CALIFORNIA COASTAL COMMISSION

Tu 19 f**RECORD PACKET COPY**

STAFF REPORT: REGULAR CALENDAR**APPLICATION NUMBER:** 5-99-405**APPLICANT:** Louis and Wendy Magur**PROJECT LOCATION:** 15245 De Pauw St., Pacific Palisades, Los Angeles County**PROJECT DESCRIPTION:** Construct a 3,839 Sq. Ft., 27 ft. above CFR single family house and garage, with 667 c.y. fill and a fenced yard.

EXHIBIT NO. 3
 APPLICATION NO.
 599 405
 Site Plan

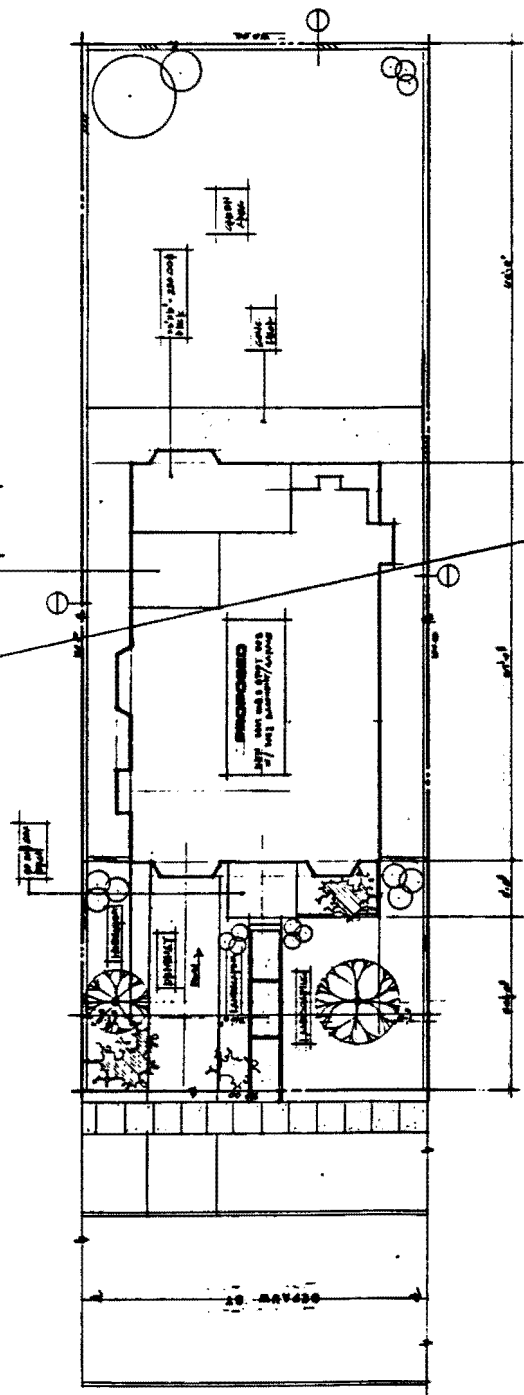
The staff recommends approval of a single-family house on this parcel only if the project can be redesigned to set back the foundation from the buttress fill. This could be accomplished either by means of a cantilever or by redesigning the house so that it is entirely located on the natural soils. With such a redesign, the house would no longer be subject to possible disaster if the buttress fill settled or if it moved along the contact with the natural soils. The applicant does not agree with this recommendation.

The Commission finds that the applicant has not demonstrated safety of this development as proposed. The material in the buttress fill could push laterally against the pilings, and cause the house to fail. When informed of this analysis, the applicant stated that the drainage devices in the fill would collect water from the fill and prevent this occurrence. In fact the engineering maps and drawings show three hydraugers in the buttress fill. These hydraugers are supposed to collect nuisance water to supply the riparian area in the canyon. These maps were reviewed by the staff geologist who still concluded that sufficient information had not been provided to remove doubts about the future safety of a house depending on pilings extending through the nonstructural fill.

Staff is recommending approval with conditions requiring the applicants to (a) provide revised plans that set back all proposed pilings no less than ten feet from the contact between natural soils and nonstructural fill, (b) provide a review of the final structural and drainage plans assuring that the plans conform to the recommendations of the geology and soils consultant and the City of Los Angeles Department of Building and Safety, (c) install no permanent irrigation system, (d) record a deed restriction assuming the risk of the development, and (e) record a deed restriction requiring a coastal development permit for any future improvement on the lot located between the west wall of the house approved in this action and the Canyon. Staff also recommends that the applicants provide a landscaping plan that allows only temporary irrigation, employs only coastal sage scrub vegetation on the fill slope and avoids the use of invasive, introduced plants that might invade the restored riparian area in the adjacent Potrero Canyon Park. Finally, the staff recommends that the applicants employ Best Management Practices appropriate to the site to limit the discharge of pollutants from the roofs and the driveway to the storm drain system.

A. Prior to issuance of the permit the applicants shall submit revised plans for the review and approval of the Executive Director. The plans shall depict the location of the surface expression of the "non-structural fill" as generally depicted in exhibit 4, and all proposed development. No rigid structures, including concrete decks, shall be placed on or over the non-structural fill, except that the applicant may place fencing, where appropriate, for safety and privacy. The pilings that are proposed to support the house shall be located outside the nonstructural fill, no closer than 10 feet from the surface expression of the contact between the "nonstructural fill " and the native soils. All development on the subject parcel shall be constructed in accordance with the revised plans unless authorized by an amendment to this permit.
